# Access Compliance Report

## Public Rights-of-Way

### (Curb Ramps)

Intersection ID: 14182	Main Street: E_PARK_AV	Cross Street: LYNDHURST_AV	Location: S
ADA ID: EC1F89EC31B4	Ramp Type: Perp	Initial Pass/Fail: Fail	Overall Compliance: No
Severity Score: 21.25			
Codes/Mitigation Info/Possible Solution		Field Measurements/Component Compliance

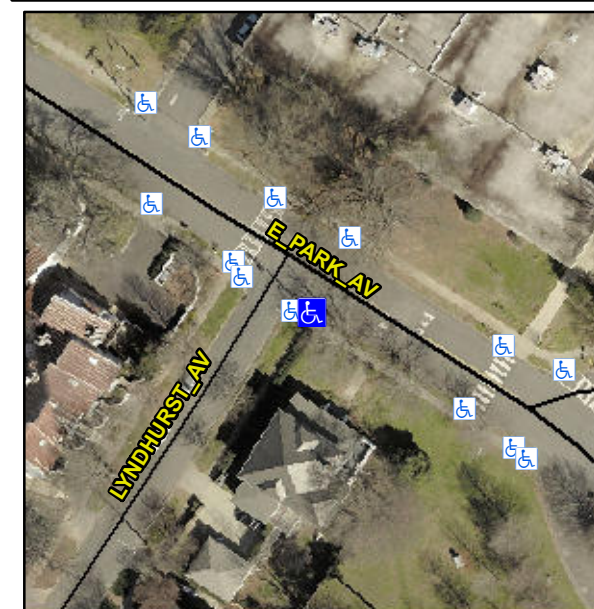
**Remove & Replace Entire Ramp.**

**R304.5.1, R304.2.2**

Compliance	Description	Data	Compliance	Description	Data
N/A	Ramp Length (in)	47.0	No	Ramp Slope (%)	11.5
No	Ramp Width (in)	36.0	Yes	Ramp XSlope (%)	0.9
N/A	Flare Type LT	N/A	N/A	Flare Type RT	N/A
N/A	Flare Slope LT (%)	N/A	N/A	Flare Slope RT (%)	N/A
N/A	Flare Traversable LT?	N/A	N/A	Flare Traversable RT?	N/A
N/A	Landing Length (in)	N/A	N/A	DWS Provided?	N/A
N/A	Landing Width (in)	N/A	N/A	DWS Contrast?	N/A
N/A	Landing Slope (%)	N/A	N/A	DWS Length (in)	N/A
N/A	Landing X Slope (%)	N/A	N/A	DWS Full Width?	N/A
N/A	Landing Curb? (Y/N)	N/A	N/A	DWS Offset (in)	N/A
N/A	Shared Landing?	N/A			
N/A	Gutter Ponding?	N/A	N/A	Gutter Slope (%)	N/A
N/A	Gutter Lip Ht (in)	3.0	N/A	Gutter X Slope (%)	N/A
N/A	Painted X Walk1?	No	N/A	Painted X Walk2?	N/A
	X Walk 1 Direction	To NE		X Walk 2 Direction	N/A
N/A	X Walk 1 Width (in)	N/A	N/A	X Walk 2 Width (in)	N/A
	X Walk 1 Slope (%)	6.5		X Walk 2 Slope (%)	N/A
	X Walk 1 X Slope (%)	5.4		X Walk 2 X Slope (%)	N/A
